Delegated Report		Analysis sheet	Expiry Date:	22/12/2021
		N/A / attached	Consultation Expiry Date:	06/01/2022
Officer			Application Number(s)	
Miriam Baptist			2021/6220/P	
Application Address			Drawing Numbers	
Lyncroft Studios, Flat 1 282 Finchley Road London NW3 7AD			Refer to Decision Notice	
PO 3/4	Area Team Signature	C&UD	Authorised Officer Signature	
Proposal(s)				
Erection of outbuilding in rear garden (retrospective).				
Recommendation(s):		Refuse and Warning of Enforcement Action to be taken		
Application Type:		Full planning permission

Assessment

1.1 Planning permission is sought for the retrospective erection of a single storey outbuilding to the rear garden as an office/for office storage. The proposal is near full width in the middle of the garden leaving 300mm on one side (150mm with the roof overhang) while 800mm remains on the other side of the plot (500mm with the roof overhang). To the rear an AC unit and services are mounted to the exterior wall and ground.

Figure C: 'Hazard: 1 in 1000 Year Flood Event' - Figure 3 ix Rev 1', extracted from Camden's

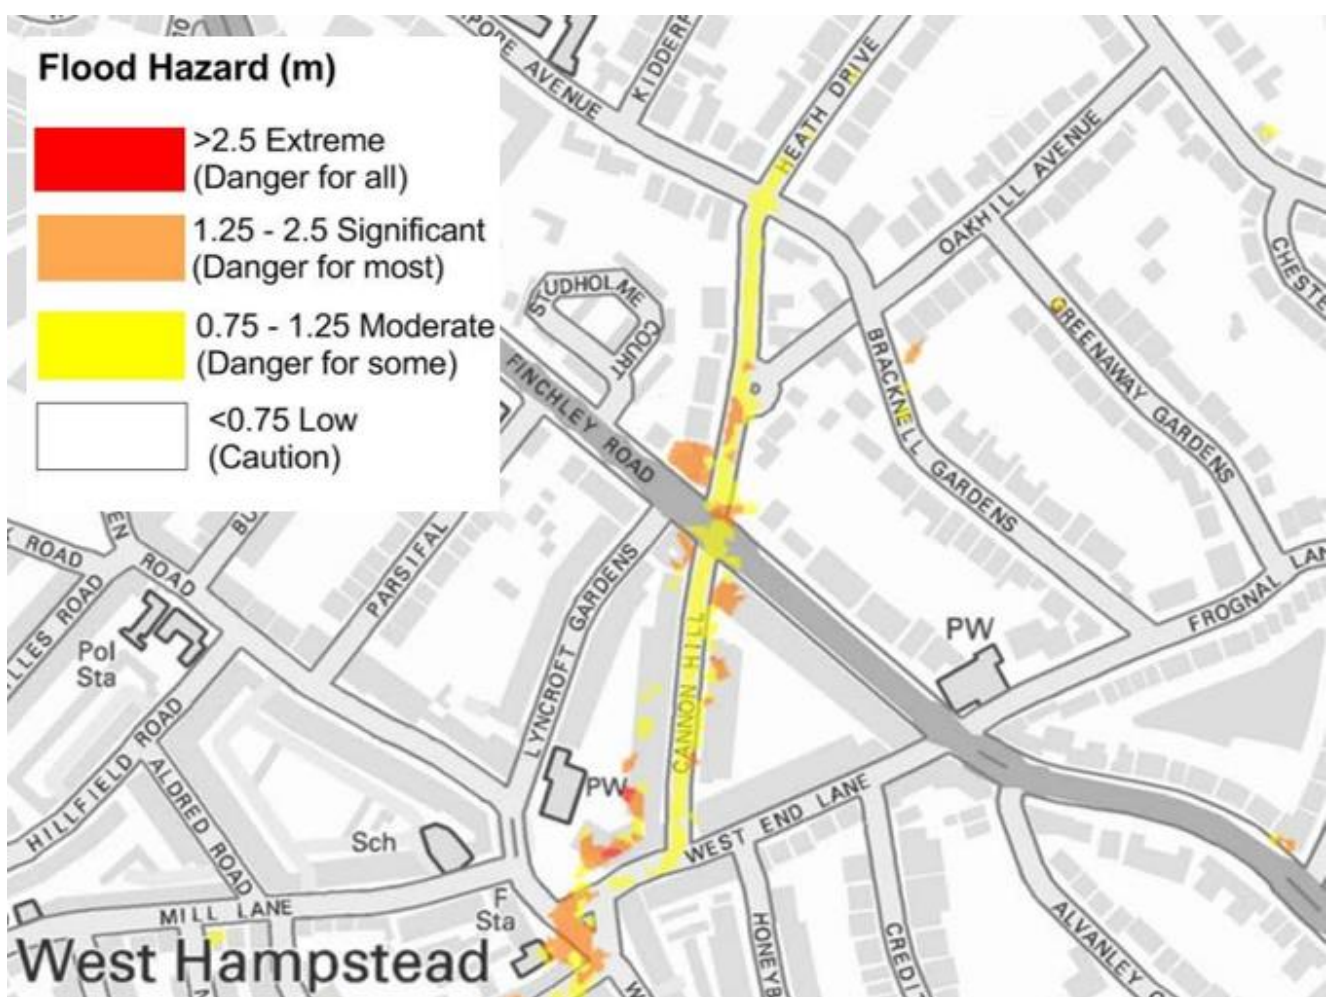
3.10 There is a history of flooding in the area, local flood maps (below) assign moderate and significant flooding risk to the immediate area. Finchley Road is identified as a previously flooded street, which flooded in 2002 and 2021. The government website for checking long term flood risk identifies the site as being of medium risk of surface water flooding (flash flooding). The development of previously undeveloped garden space will exacerbate the site's vulnerability to flooding at some level, and subsequently site(s) in close proximity that are shown in Figure C below to be at significant flood hazard risk.

3.11 The proposal does not introduce any permeable surfaces or bio-diverse roofing and will by nature increase surface water run-off in an area already susceptible to flooding in extreme rainfall events. For these reasons the proposal is not considered to respond to Camden's Policy CC3 to ensure that development "does not increase flood risk and reduces the risk of flooding where possible". The application is therefore recommended for refusal on this basis also.
